Witberg Wind Energy Facility and associated infrastructure, Western Cape Province

Revised Motivation for amendment of Environmental Authorisation

DEA Ref.: 12/12/20/1966/AM7

March 2019

Figure 7.1: Final Updated Layout for the Proposed Amendment
 Motivation Report

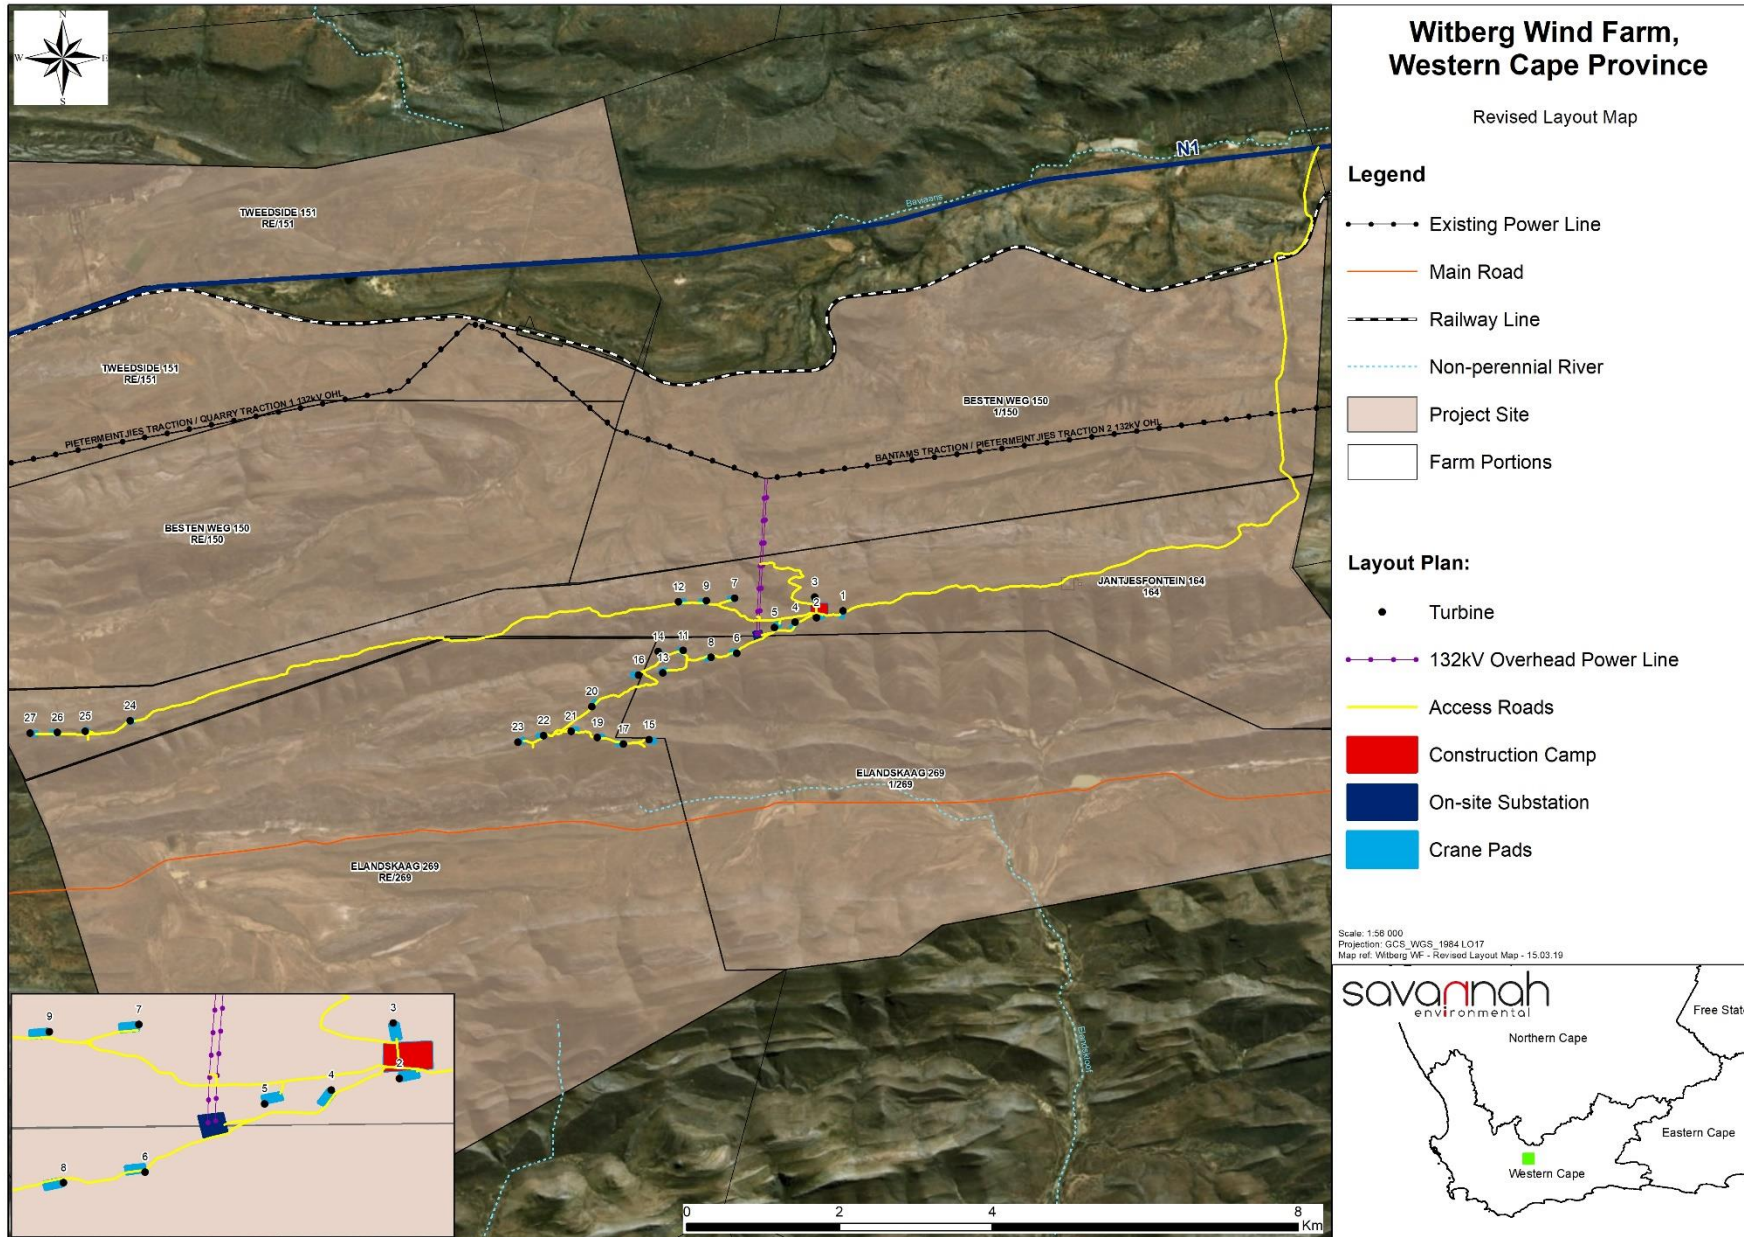
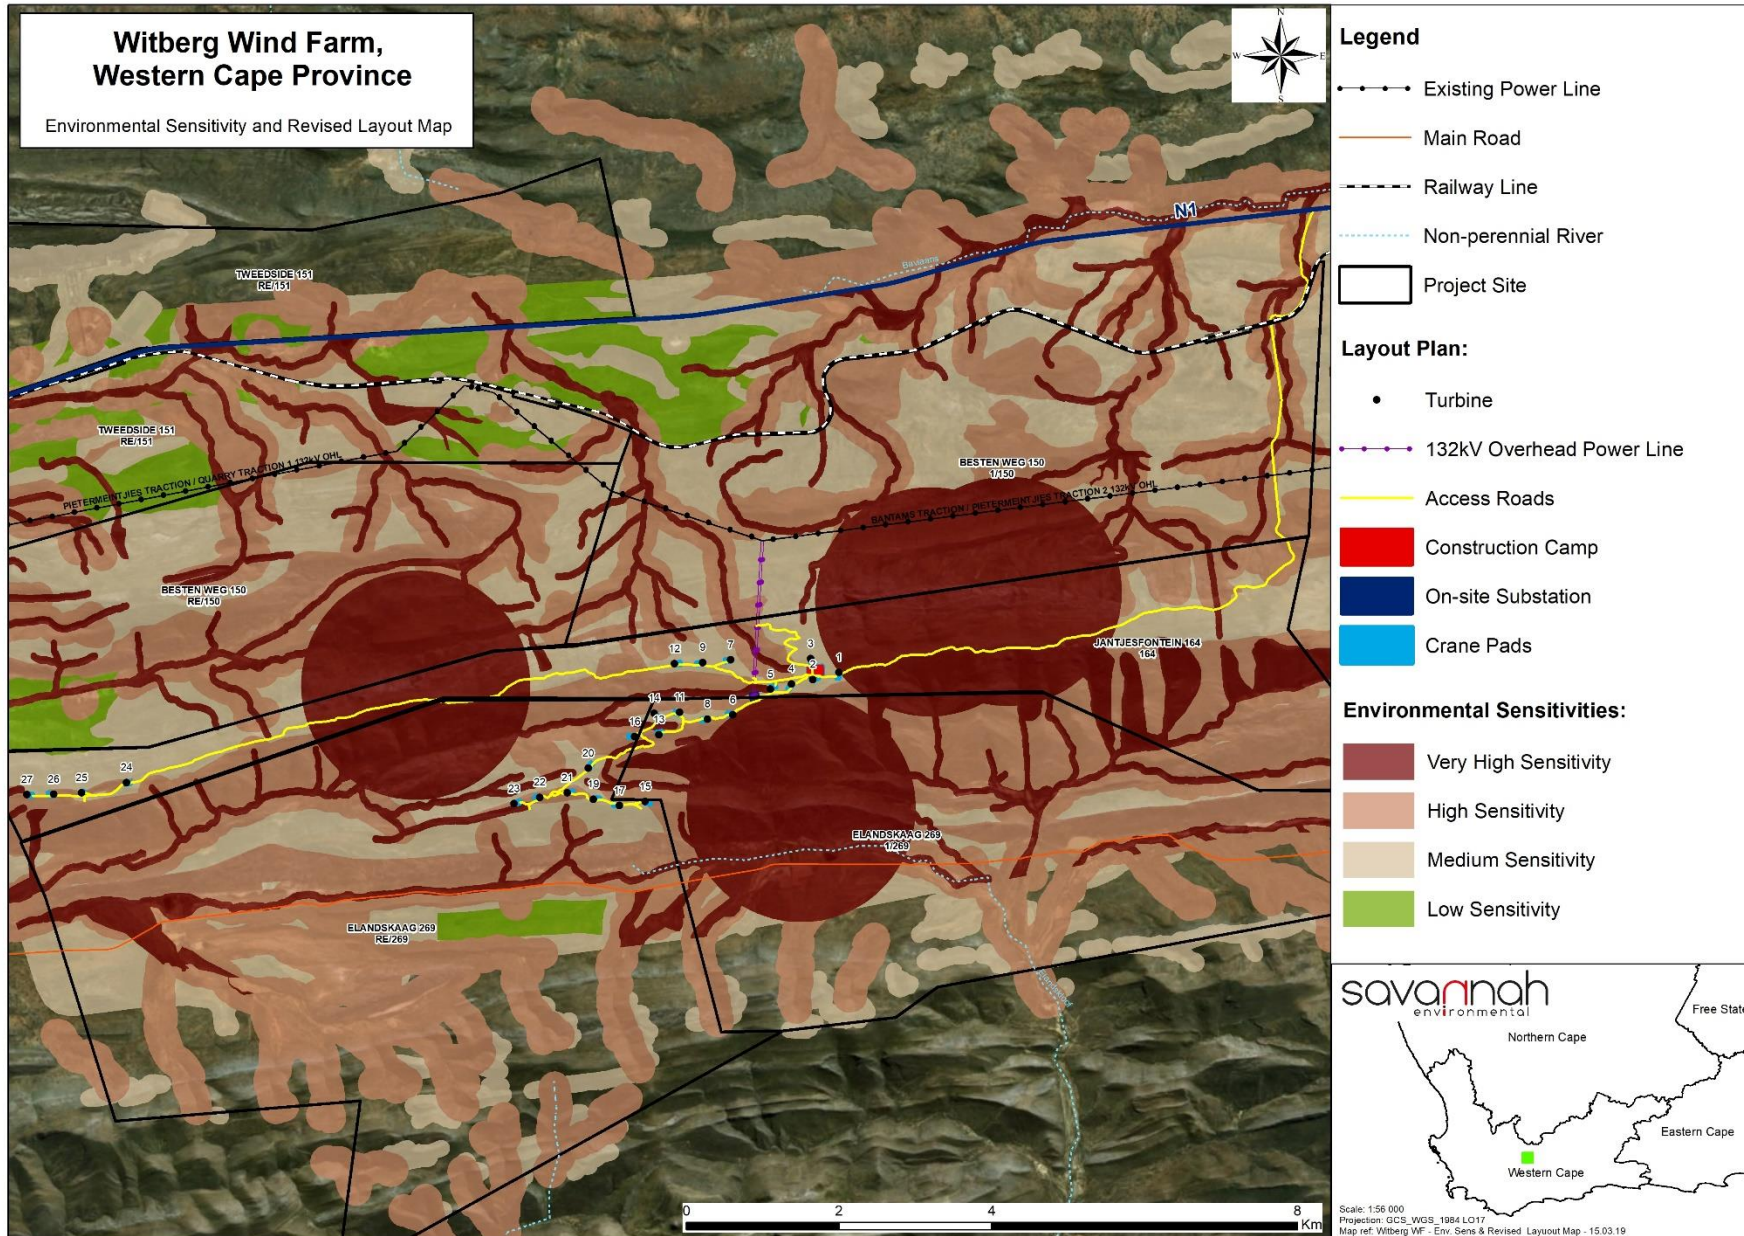
DEA Ref	Comments from DEA on the initial Motivation Report	Report Reference and Response from EAP
	<ul style="list-style-type: none"> All necessary details regarding all possible locations and sizes of the proposed satellite substation, the main substation and internal powerlines. All existing infrastructure on the site, especially internal roads infrastructure. The location of sensitive environmental features on site e.g. CBAs, heritage sites, wetlands, drainage lines etc. that will be affected by the facility and its associated infrastructure. Buffer areas. All "no-go" areas. 	
(c)(iv)	The final report must include an environmental sensitivity map indicating environmental sensitive areas and features identified during the assessment process.	Refer to Figure 7.1 and Figure 7.2 of the Revised Motivation Report.
(c)(v)	The final report must include a map combining the final layout map superimposed (overlain) on the environmental sensitivity map.	Refer to Figure 7.1 and Figure 7.2 of the Revised Motivation Report.

- » Substation to be outside the 1.5km buffer;
- » Lay-down area to be outside the 1.5km buffer;
- » Crane stand 5 and 6 to be outside the 1.5km buffer;
- » Crane stand 15 and part of this road has been moved (outside bat buffer);
- » Partial road alignment within the 1.5km buffer re-aligned outside of 1.5km buffer; and
- » Lay-down area moved to between wind turbines 2 and 3 to be outside the 1.5km buffer;

The additional relocation of the above components is shown in **Figure 7.1** below. The associated environmental sensitivities overlaid by the proposed layout is shown in **Figure 7.2** below. The proposed layouts below are the final proposal layout for consideration in this amendment application.
